## 4 IN1 CARD-READER (SD/SD IO/MMC/MMC4.0/MS/MS PRO/XD)

Ferrari 7 Cardreader Schematic EC Tracking Record ( For SA ) Jun.15 , 2007  
EC #/ Page / Description / Part Affected

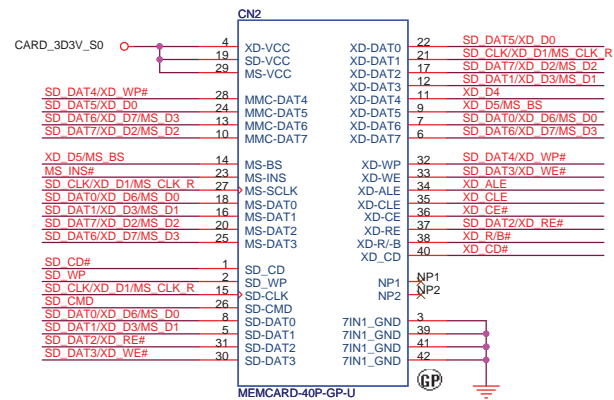
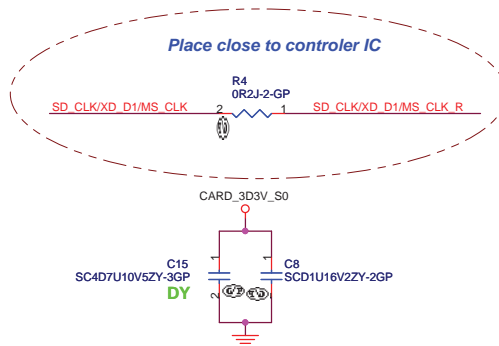
- EC SA01/01/ 1. Change X1 P/N from "82.30006.261" to "82.30006.271", the reason is reduce package size.  
2. Change C11,C12 from 20pF to 27pF for crystal accuracy.
- EC SA02/01/ Change C14 from 0.1uF dummy to 47pF.
- EC SA03/01/ Reserve for VBUS=3.3V input.
- EC SA04/01/ Delete R3 resistor, the reason is reduce component count.
- EC SA05/01/ Delete R1,R2 resistor, the reason is reduce component count.
- EC SA06/01/ Reserve for debug use.
- EC SA07/01/ 未完成 !!!
